Avon Advisory Planning Commission Meeting  
**Monday, February 23, 2026** at 6:30 pm  
at Avon Town Hall

Planning & Building Department Staff Report

<b>A. PETITION NUMBER</b>	DPR 25-12: 267 Park Place Crossing
<b>B. APPLICANT</b>	Tranquility, LLC, by Kruse Consulting, Inc.
<b>C. LOCATION</b>	56, 82, & 108 Park Place Boulevard (approximate addresses)  Lots 5, 6, & 7 in Avon Park Place
<b>D. PARCEL SIZE</b>	1.68 acres
<b>E. LAND USE &amp; ZONING</b>	The site is undeveloped, is zoned C-2: General Commercial District, and located within Tiers 1 & 2 of the U.S. Highway 36 Zoning Overlay.
<b>F. ACTION REQUESTED</b>	Request for approval of a Development Plan Review to allow for construction of a one-story, multi-tenant commercial building with surface parking and related improvements.
<b>G. HISTORY</b>	<p>The site was platted and recorded in 1988 under the jurisdiction of Hendricks County.</p> <p>This petition was discussed at the September 18, 2025 Technical Advisory Committee (TAC) meeting, and accordingly docketed for the October 27, 2025 Plan Commission (PC) meeting. The petition was continued to the December 22, 2025 meeting, and then to the January 26, 2026 hearing to allow for th

## Exhibit B2 – Revised Site Plan (6-Feb-2026)

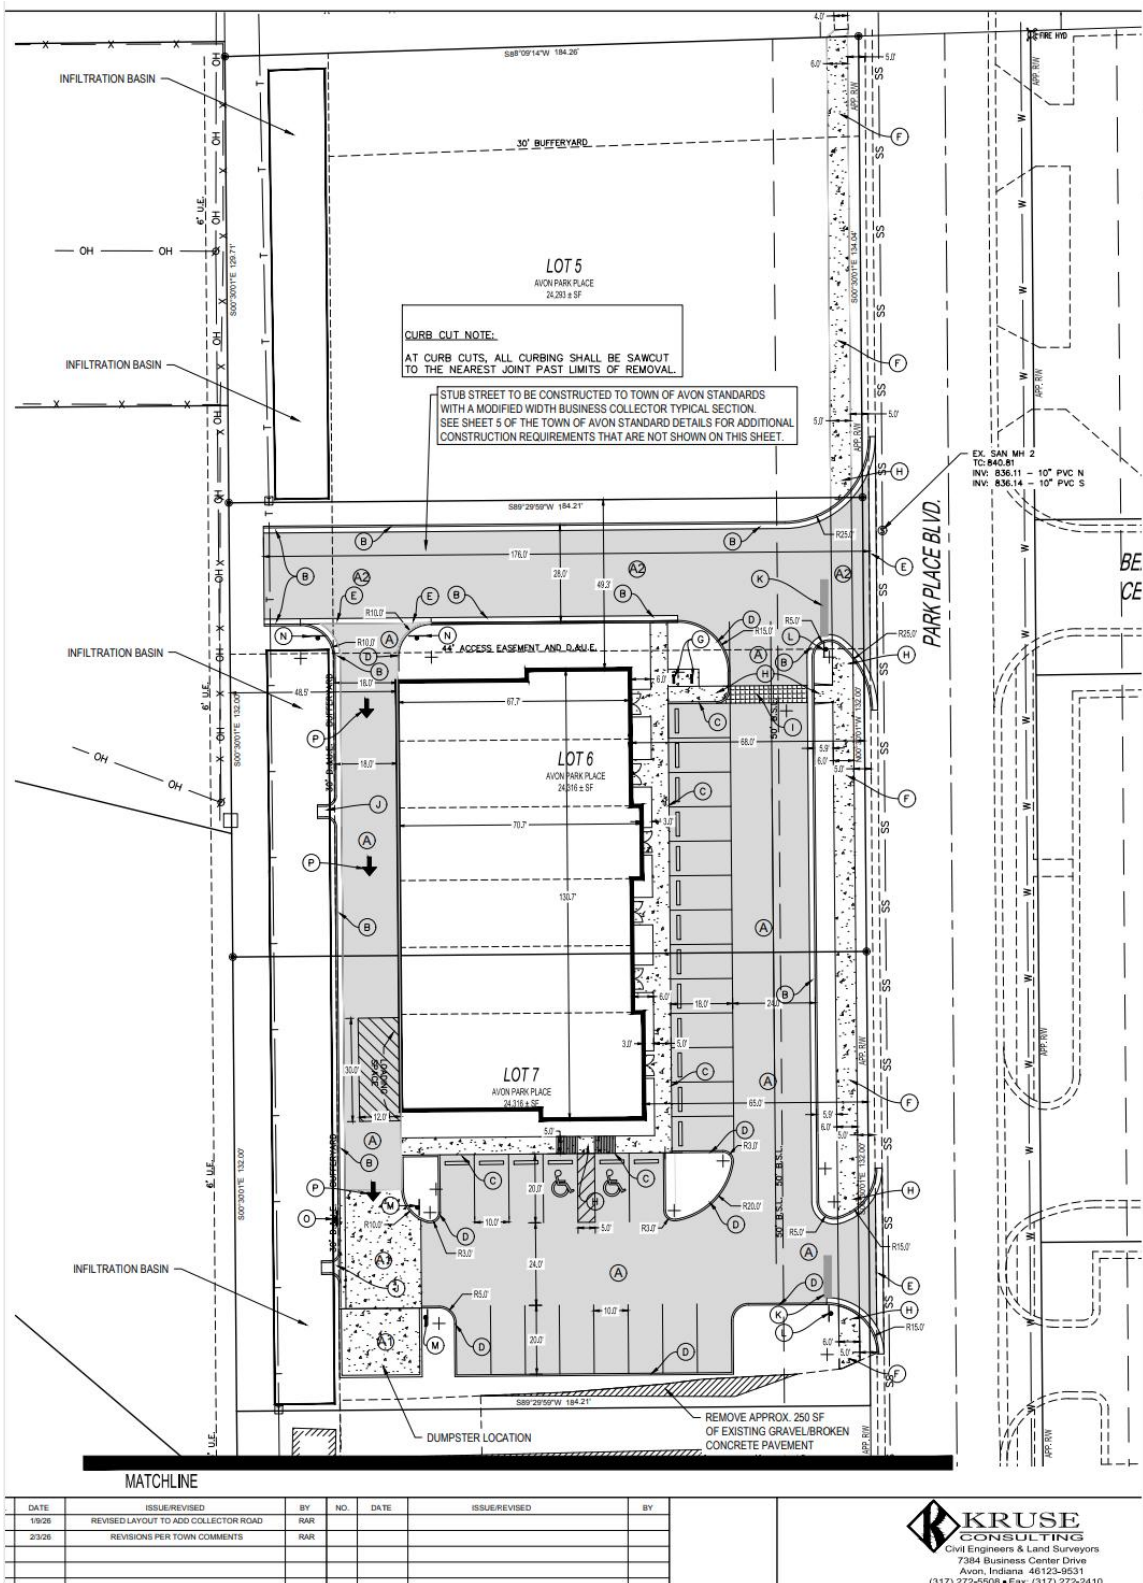
a) **Parking:** The site plan proposes 27 spaces. UDO Table 6.3 specifies the required amount of off-street parking based upon the type of commercial use that occupies each building, such as two (2) spaces per 1,000 square feet of Gross Floor Area (GFA) for general office use, two and one-half (2.5) spaces per 1,000 for retail sales, and five (5) parking spaces per 1,000 for restaurants or taverns. The proposed three (3) spaces per 1,000 square feet of GFA would meet the requirement for either general office or retail uses. If permitted uses requiring additional parking are proposed in the future, additional parking could be required at that time.

b) **Loading:** A loading space, as required, is identified on the site plan at the rear of the building in a location that does not prevent ingress/egress to any parking areas.

Waiver: A waiver of development standards of UDO Table 6.1 to provide for a row of 18-foot deep off-street parking spaces (minimum 20-foot parking space depth required).

Waiver: A waiver of design standards of UDO 7.21(E) to provide for a full-access driveway onto Park Place Boulevard offset from two existing driveways on the opposite side of the street (minimum 150-foot separation required).

**Staff concurs with the petitioner's response. A 10' x 18' parking space with a 24' two-way drive aisle will provide adequate maneuvering for drivers visiting an office development that typically has lower parking lot turnover than many other retail commercial uses.**

Staff concurs with the petitioner's response. The proposed location being generally centered opposite two existing

# Exhibit B3 – Revised Landscape Plan (6-Feb-2026)

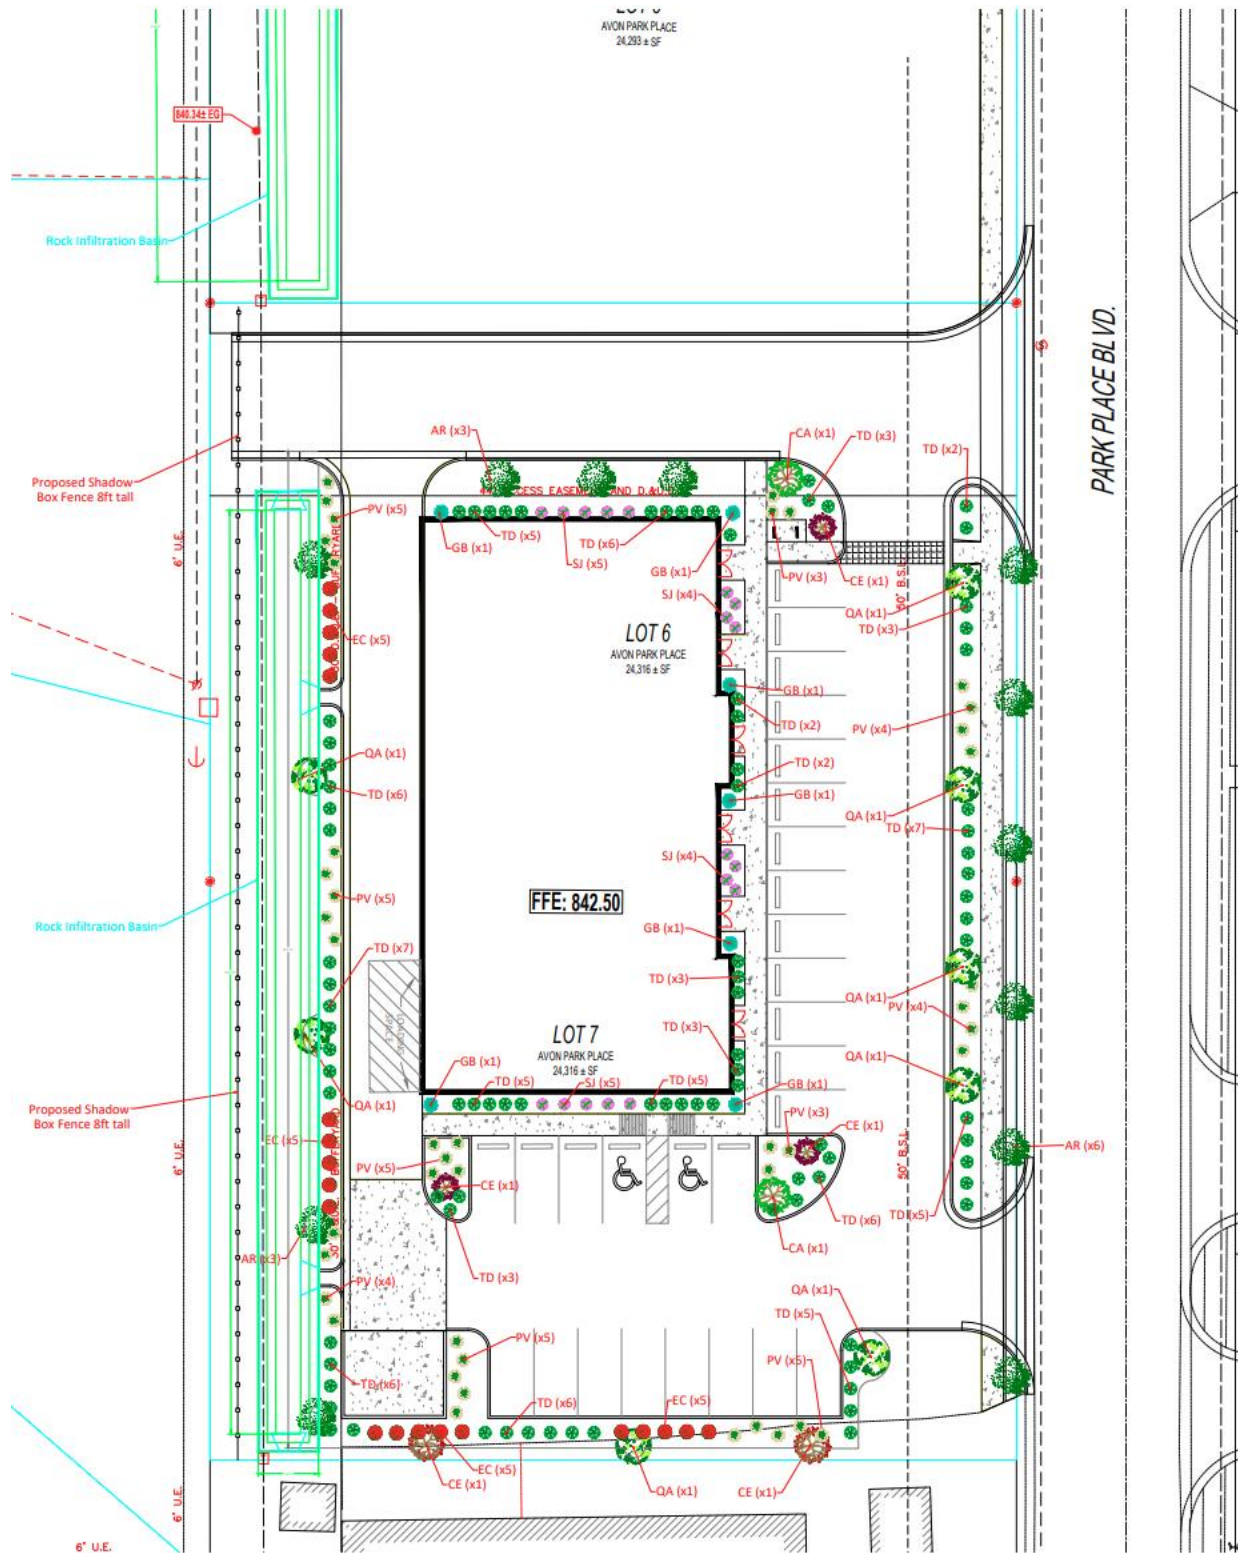
Except for Waivers B & D to reduce the front buffer yard and foundation planting areas, the proposed landscape plan appears to meet all other requirements of the UDO.

Waiver: A waiver of development standards of UDO 2.10(M)(1) to provide for a 16.9-foot front landscape buffer with sidewalk therein (minimum 20-foot front landscape buffer required).

Waiver: A waiver of development standards of UDO 6.5(A) to provide for no foundation planting area adjacent to the west façade and a reduced width of foundation planting area along portions of the east façade (minimum 5-foot wide planting area required around the building except at loading areas and doorways);

Staff concurs with the petitioner’s response. The request is a minor deviation from the standard and will not preclude meeting the overall required number and type of landscape plantings.

**Staff concurs with the petitioner’s response. The limited depth of the site, along with the requirement to construct an extension of Beechwood Centre Road, present challenges in meeting all development standards. However, the overall proposal would be harmonious with the purpose and intent of the zoning district.**

# Exhibit B – Revised Site Plan (5-January-2026)

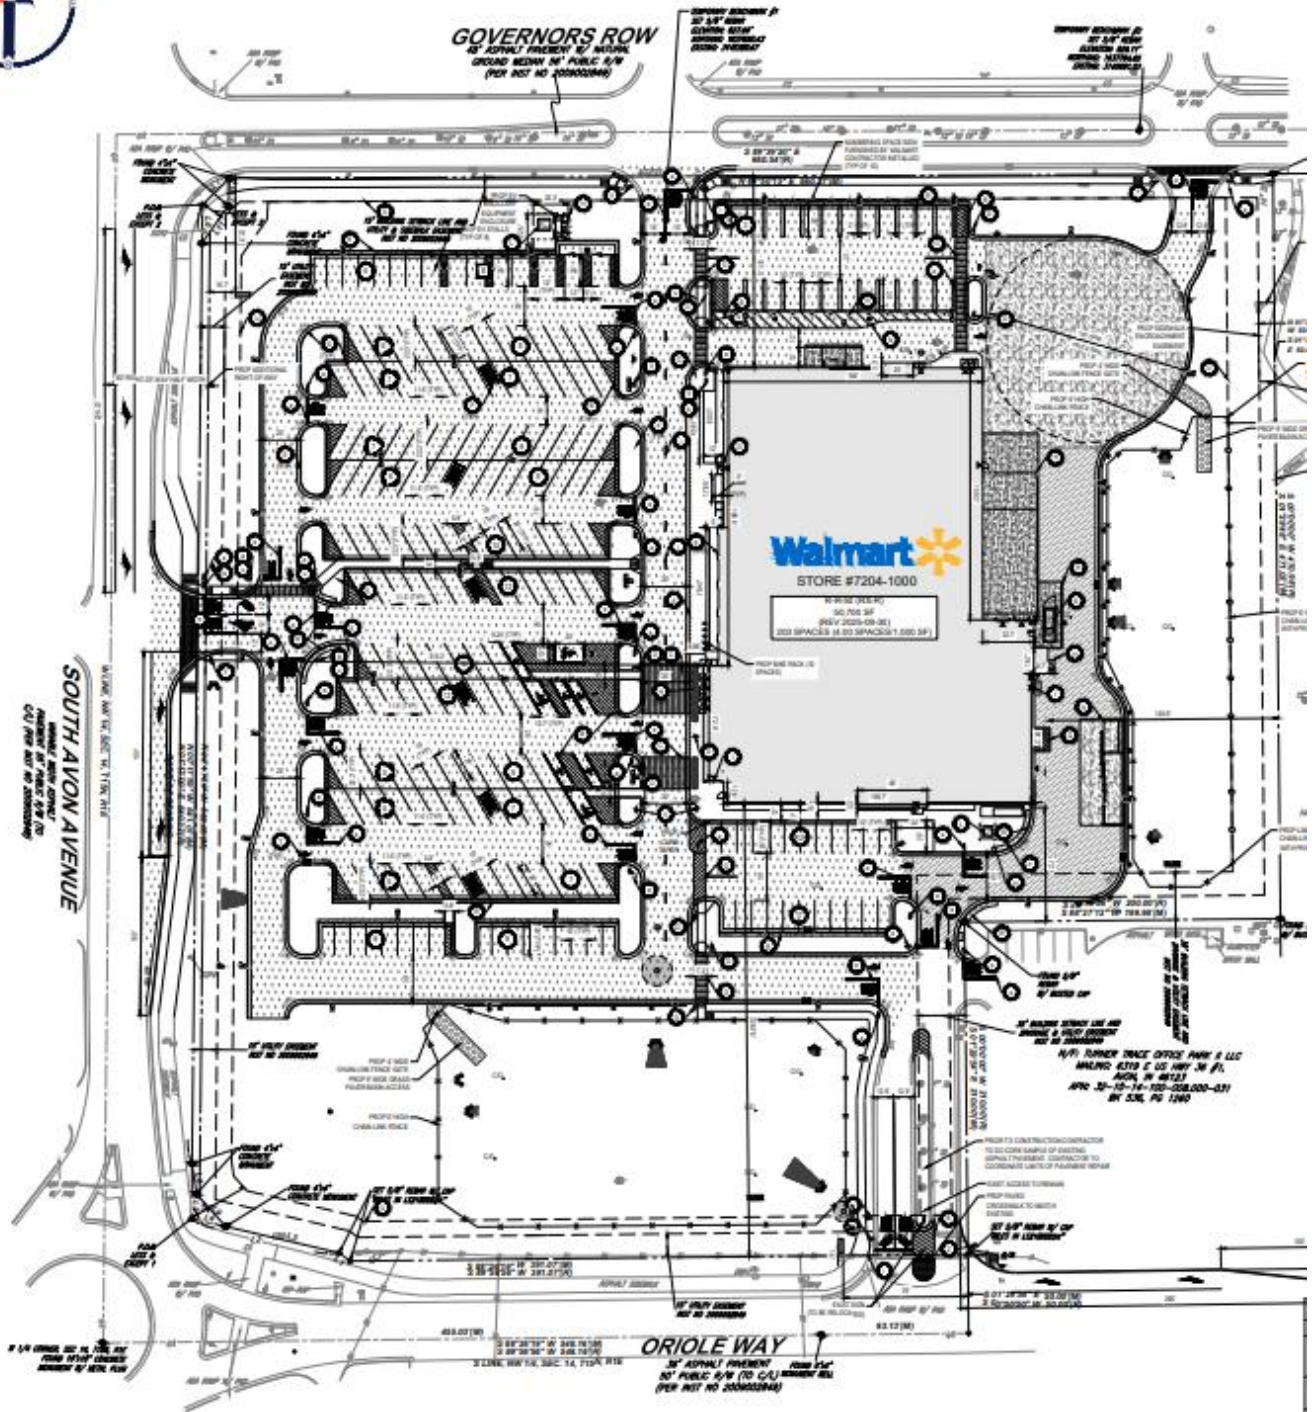
- a) **Parking:** The site plan indicates the provision of 225 off-street vehicle parking spaces, with eight (8) of those being reserved accessible spaces. UDO Table 6.3 specifies that a minimum of 2.5 spaces per 1,000 square feet of gross floor area for a grocery store or other retail use, thus, a minimum of 127 spaces would be required for the proposed 50,700-square foot store. Based on the overall number of spaces provided, a minimum of seven (7) reserved accessible spaces would be required.

- b) **Loading:** Retail buildings between 7,500 and 75,000 square feet are required to provide a minimum of one (1) dedicated loading space. The site plan indicates two (2) dedicated loading spaces meeting the spatial requirements for tractor-trailer deliveries.

- c) **Bicycle Parking:** The UDO requires one bicycle rack per every twenty (20) required vehicle parking spaces, thus, six (6) bicycle racks would be required. While the revised site plan shows bicycle racks in a compliant location, the plan only indicates five racks. At least one additional rack would be required.

# Exhibit C1 – Revised Landscape Plan (2-January-2026)

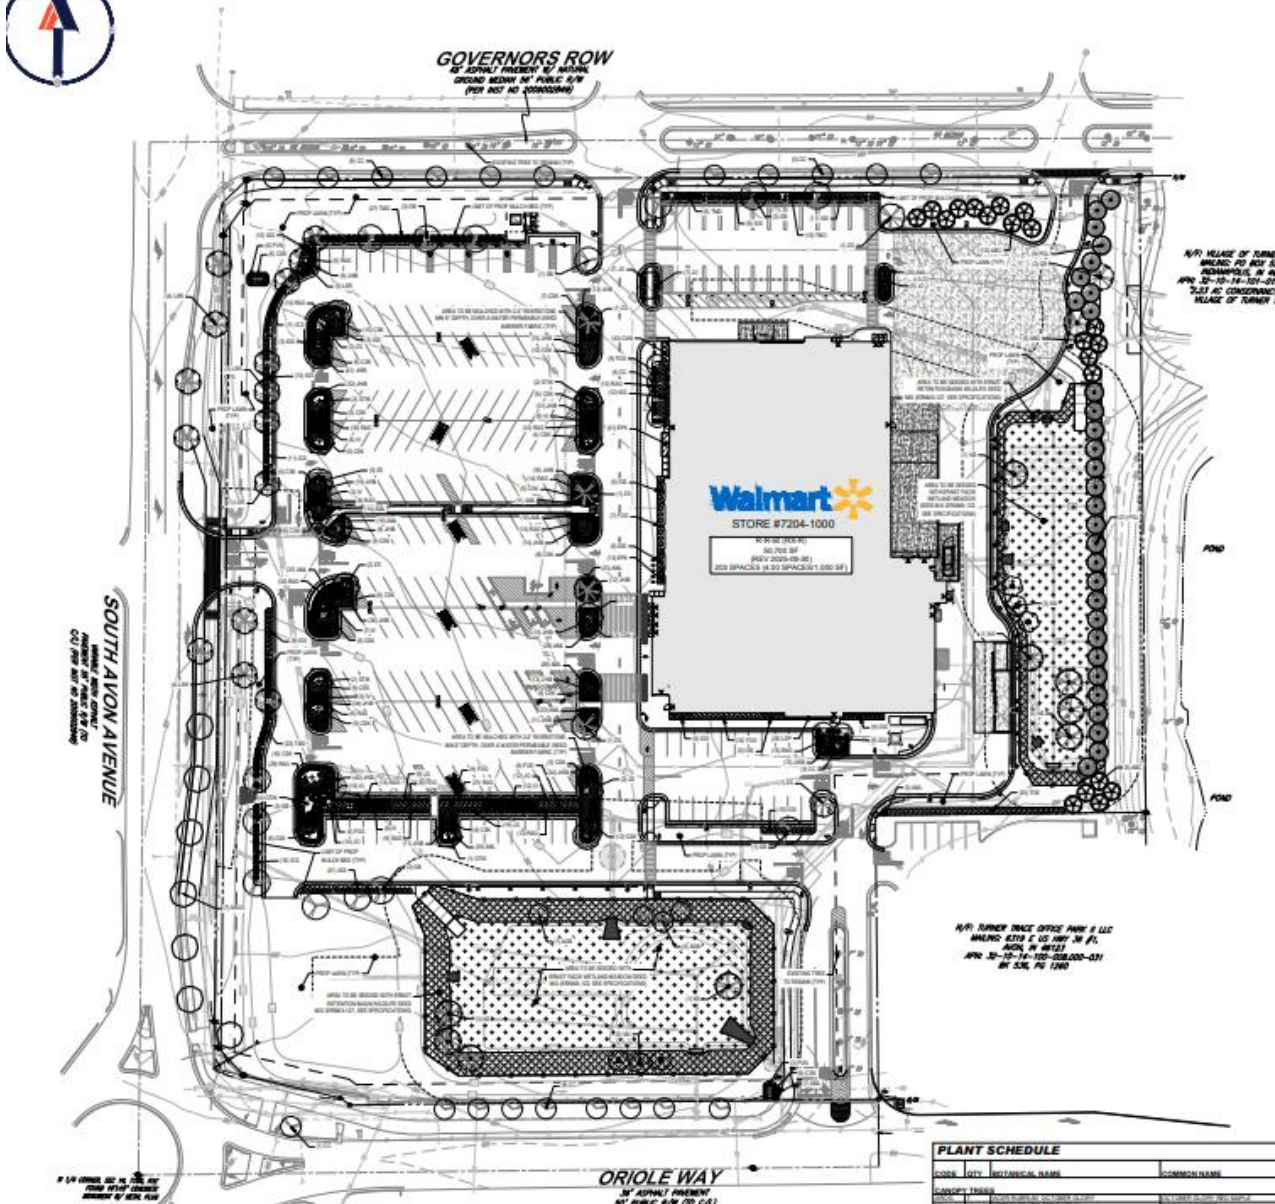
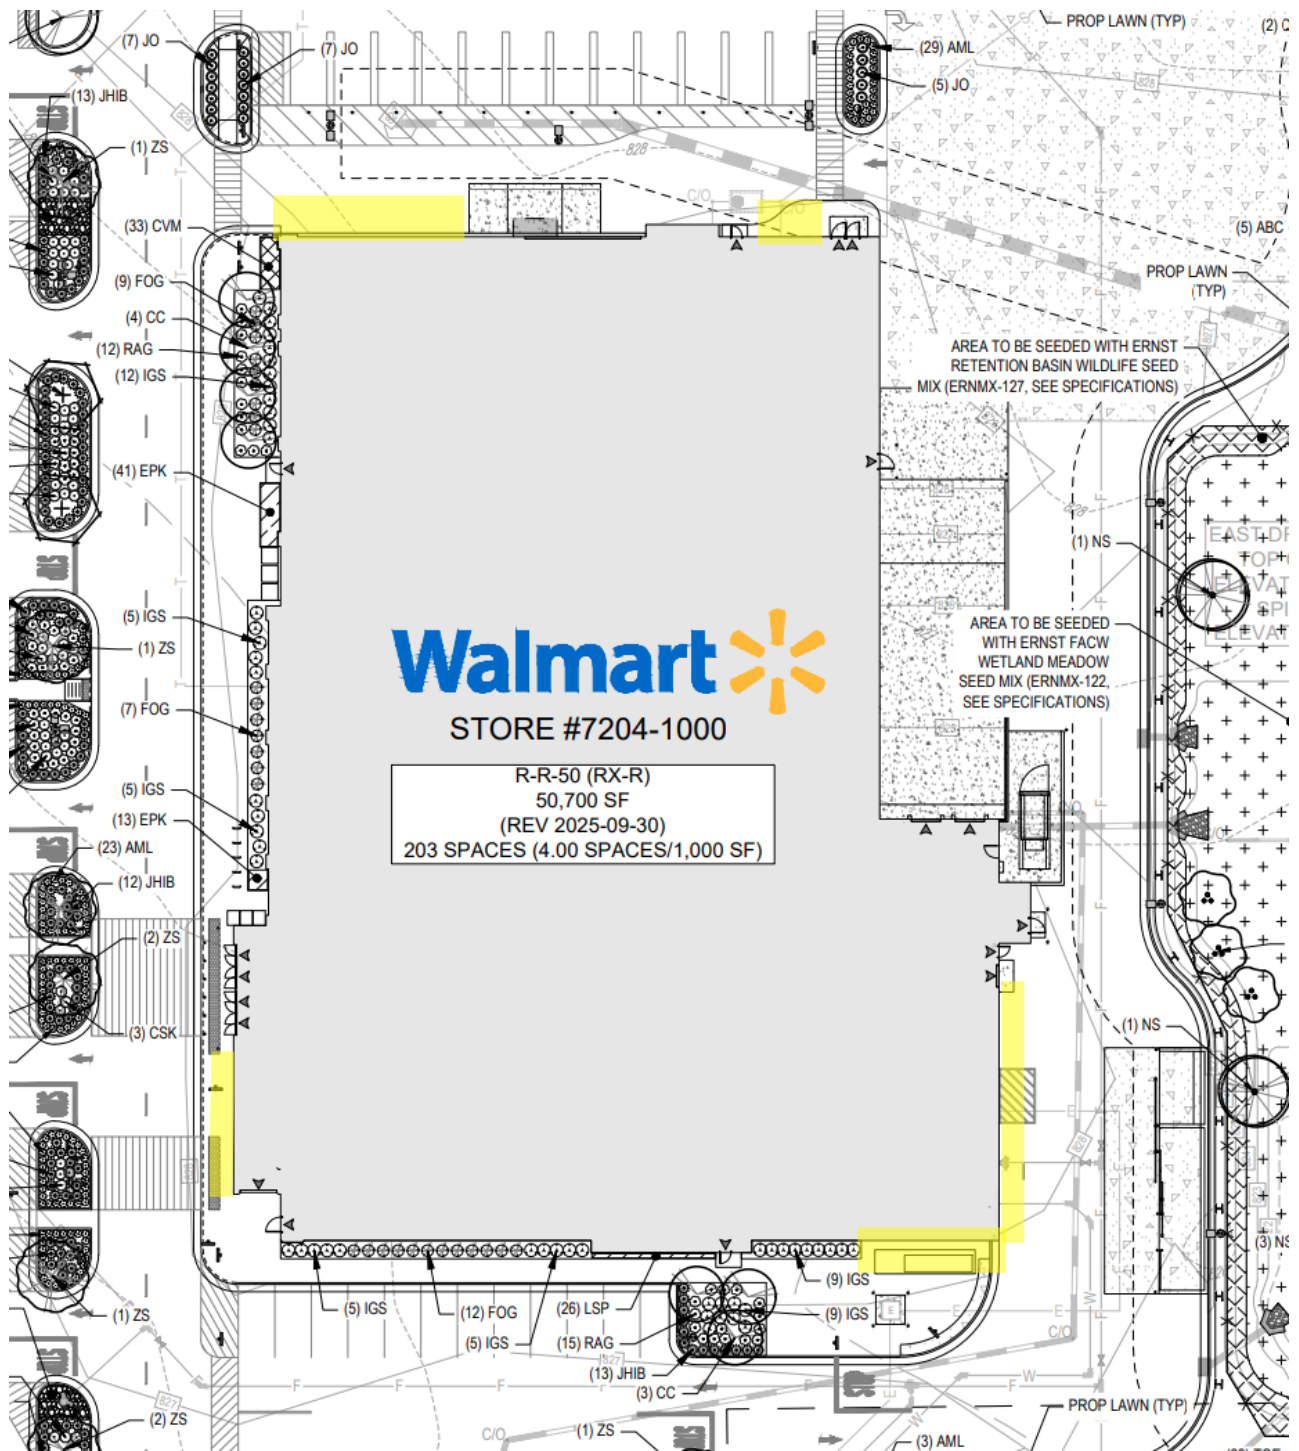
Per UDO 6.5 (A), a minimum five-foot planting area must be provided around the perimeter of the building, excluding access to the buildings, such as loading areas and doorways. The landscape plan submitted subsequent to TAC review has increased the proposed foundation planting areas, but is still deficient along several portions of the building (see Exhibits C1 & C2).

Per UDO 6.7(B)(4), each parking lot landscape island must have a minimum of one tree. The revised landscape plan is still deficient of this standard.

A further revised landscape plan should be submitted to demonstrate compliance with the foundation planting and interior parking lot landscaping requirements.
